## Riley Purgatory Bluff Creek Watershed District Permit Application Review

**Permit No:** 2023-064

**Project:** Rainbow Drive Culvert Replacement – The proposed project includes replacement of an existing large arch corrugated metal culvert that conveys Purgatory Creek under Rainbow Drive in the vicinity of Eden Prairie Road in Eden Prairie.

**Reviewer:** Scott Sobiech, PE, Barr Engineering

**CITY OF EDEN PRAIRIE**  
 EROSION CONTROL AND TURF ESTABLISHMENT PLAN  
 RAINBOW DRIVE CULVERT REPLACEMENT

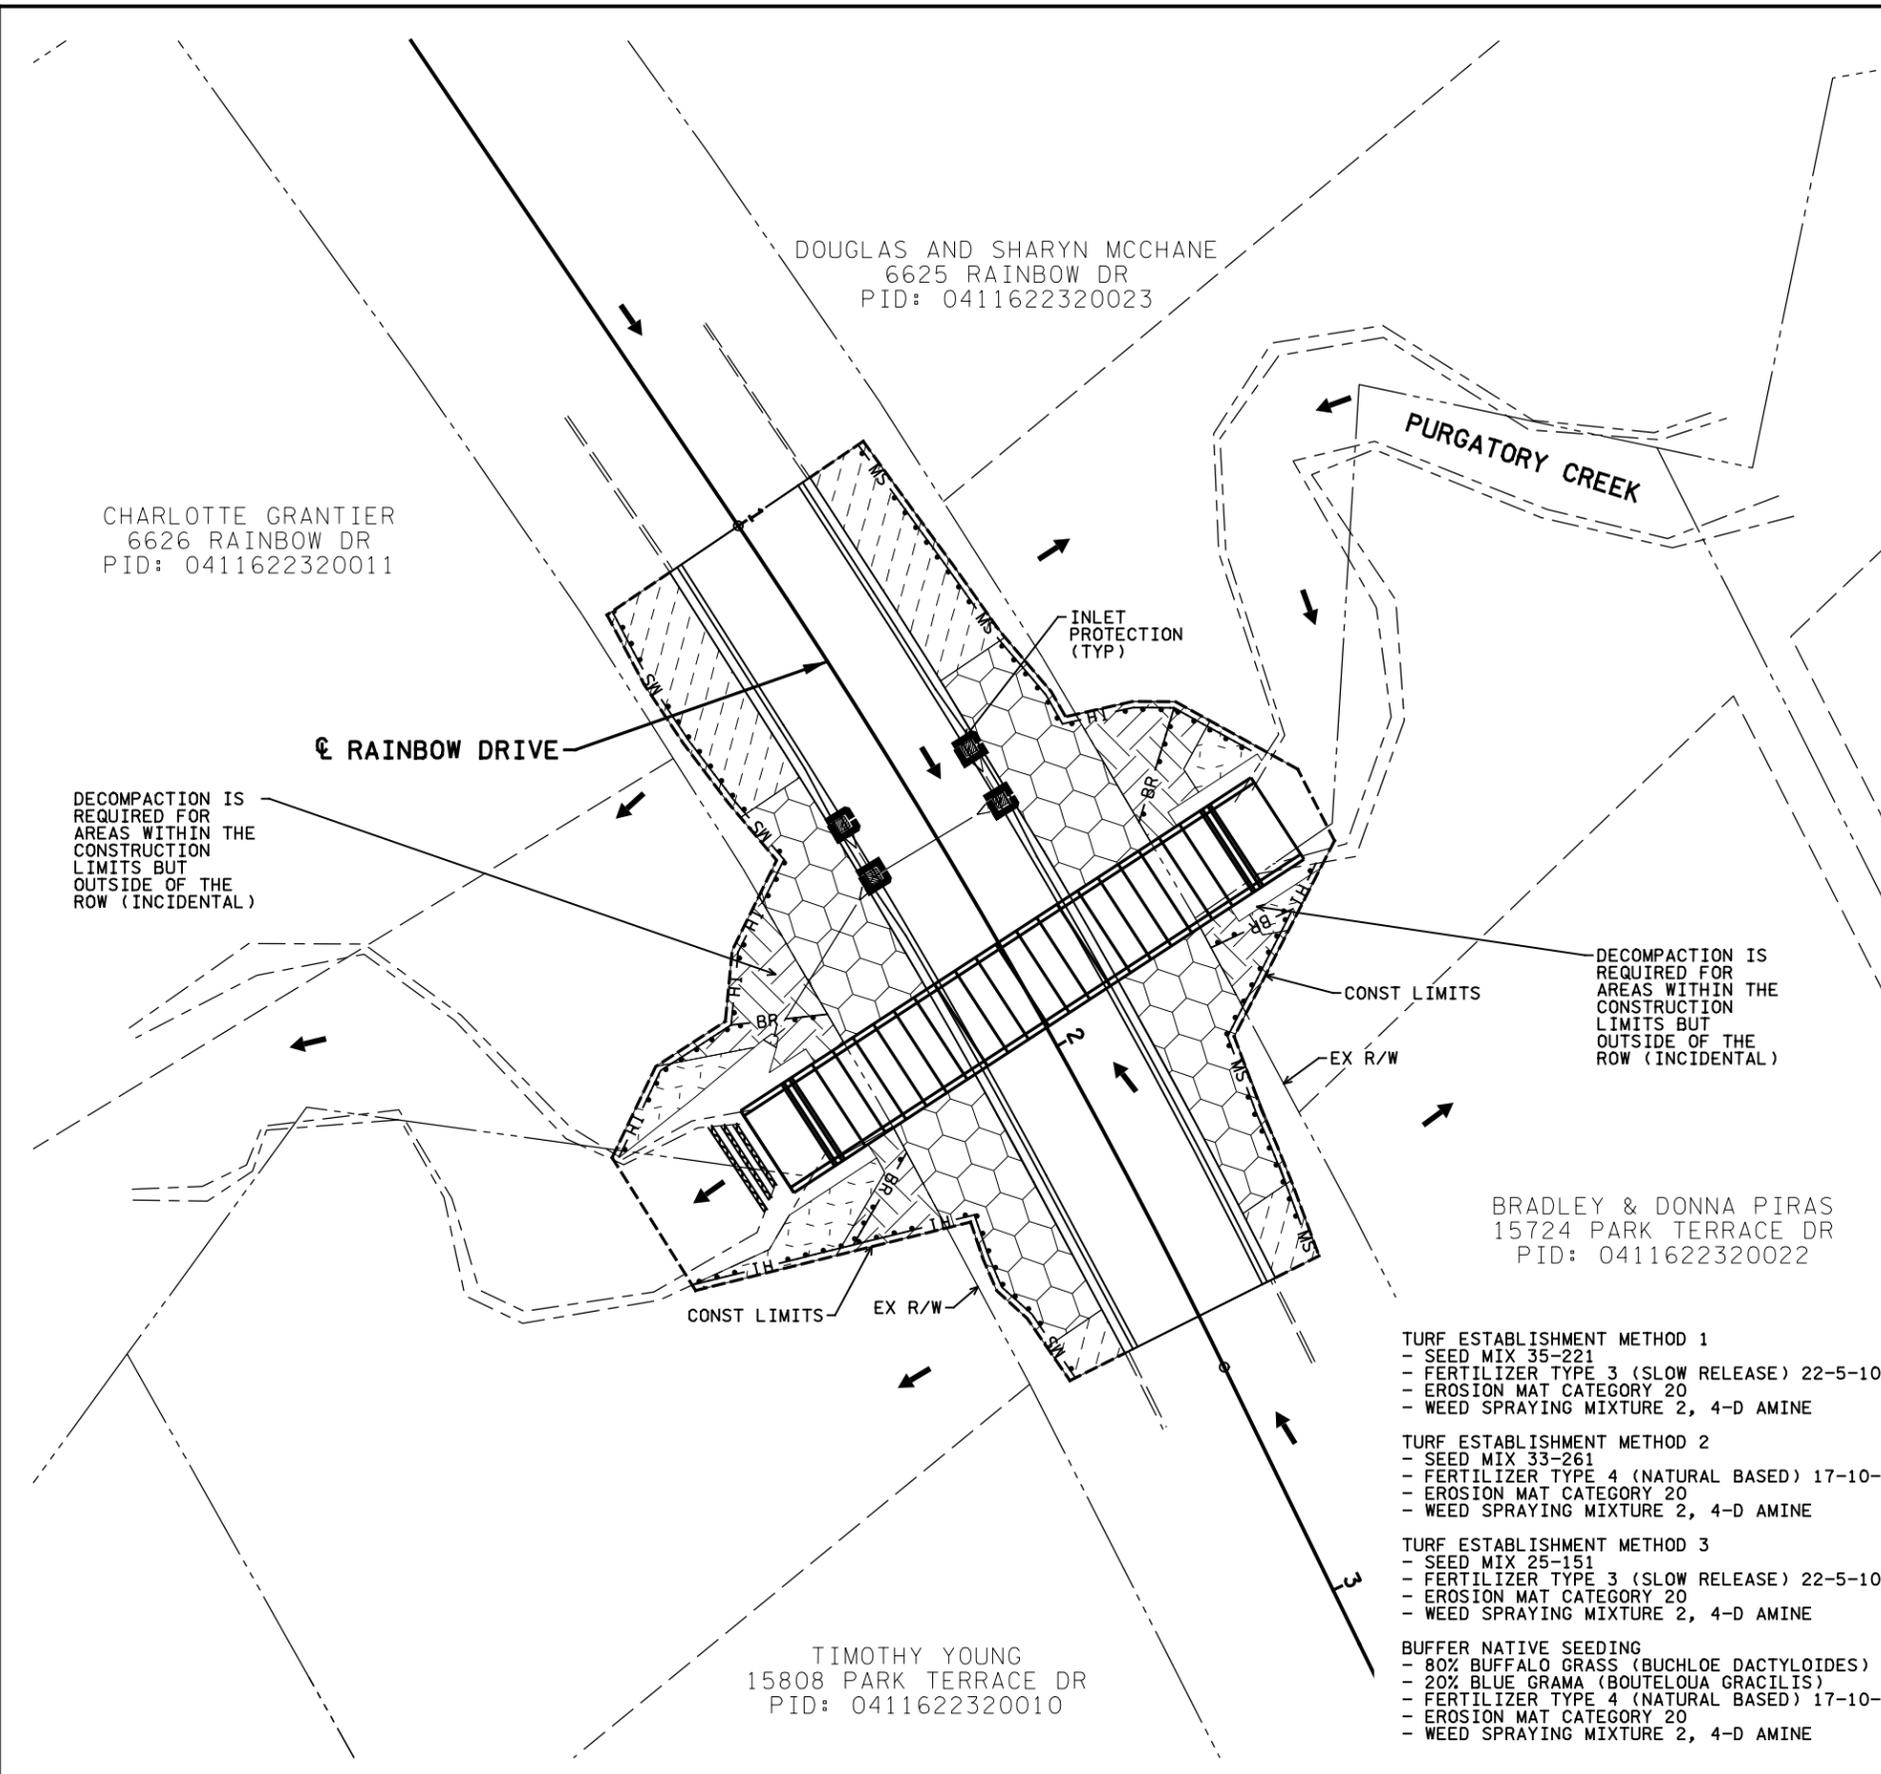
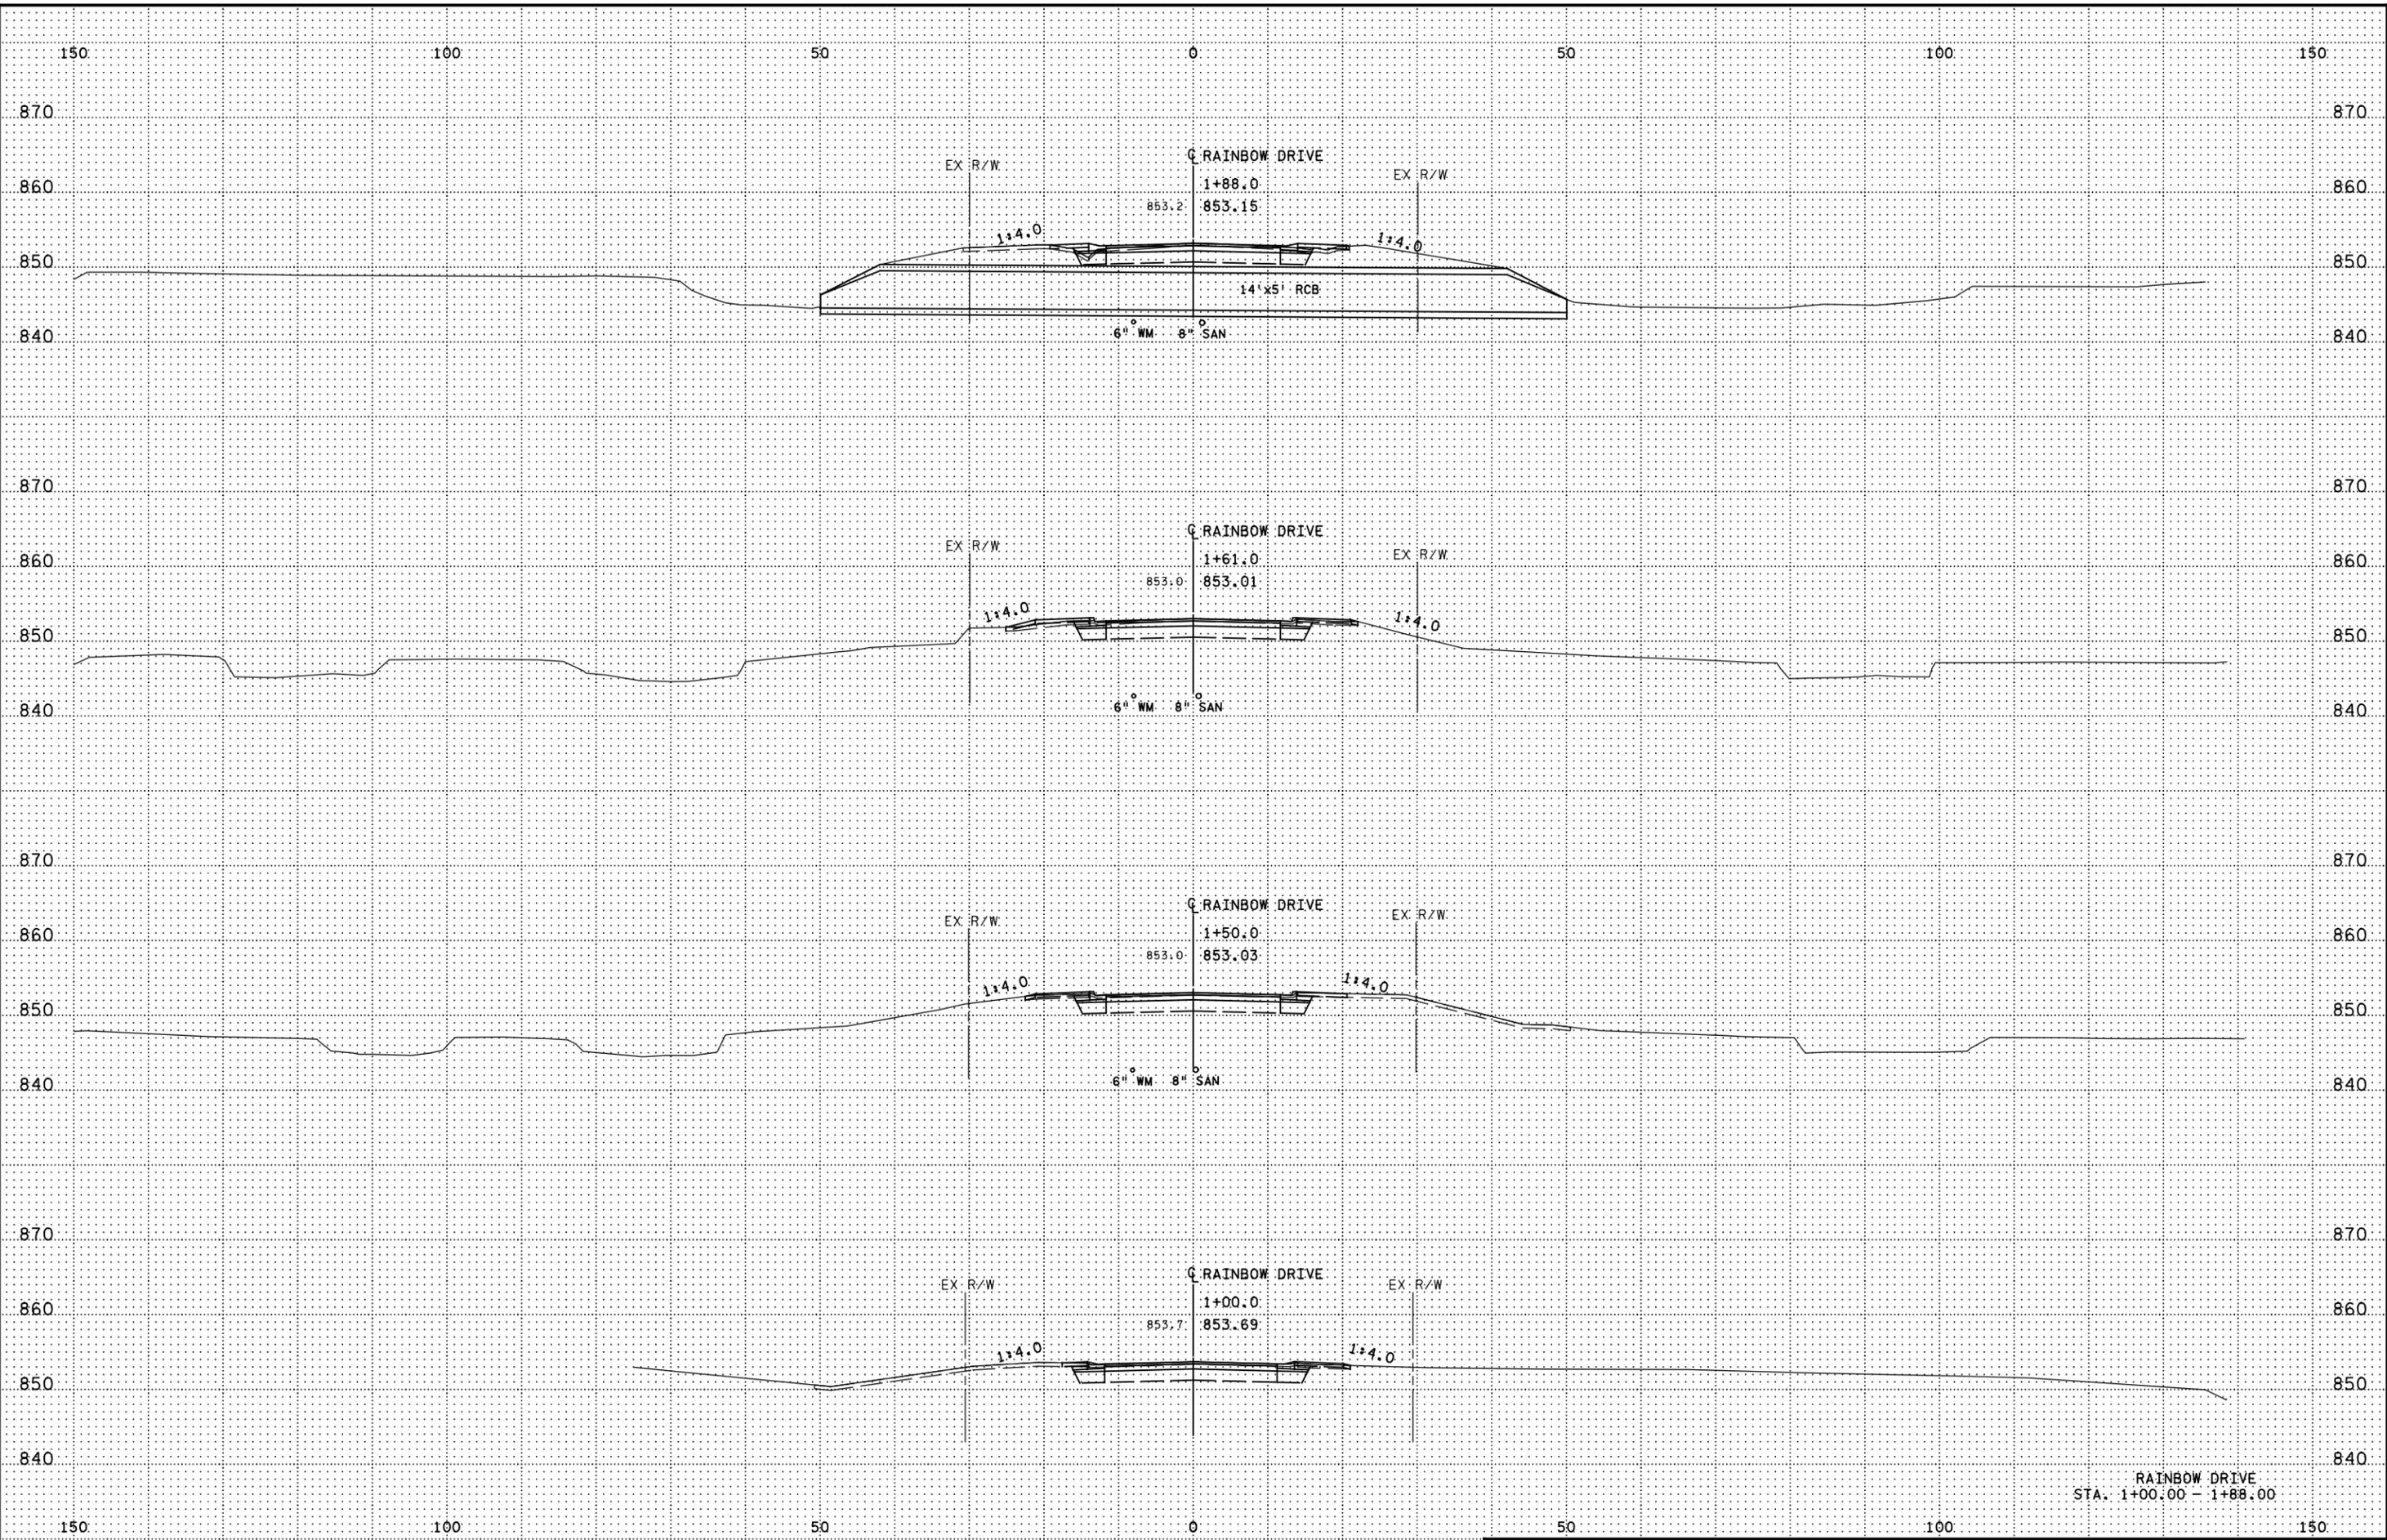
The erosion control/turf restoration plan includes installation of silt fence, biolog, inlet protection for storm sewer catch basins, floating silt curtain, turf establishment, daily inspection, placement of a minimum of 6 inches of topsoil, decompaction of areas compacted during construction, and retention of native topsoil onsite. To conform to the RPBCWD Rule C requirements the following revisions are needed:

- C1. Revise the erosion control/turf restoration plan to require topsoil containing at least 5% organic matter.
- C2. The Applicant must provide the name and contact information of the individual responsible for erosion control at the site. RPBCWD must be notified if the responsible individual changes during the permit term.

1. Continued compliance with General Requirements.
2. Receipt of revised construction drawings requiring topsoil containing at least 5% organic matter.
3. The Applicant must provide the name and contact information of the individual responsible for erosion control at the site. RPBCWD must be notified if the responsible individual changes during the permit term.
4. RPBCWD and Eden Prairie have entered into a programmatic maintenance agreement covering city projects subject to RPBCWD regulatory requirements. The buffers and waterbody crossing associated with this permit (2023-064) must be incorporated into the inventory of those managed in accordance with the programmatic agreement as a condition of approval.
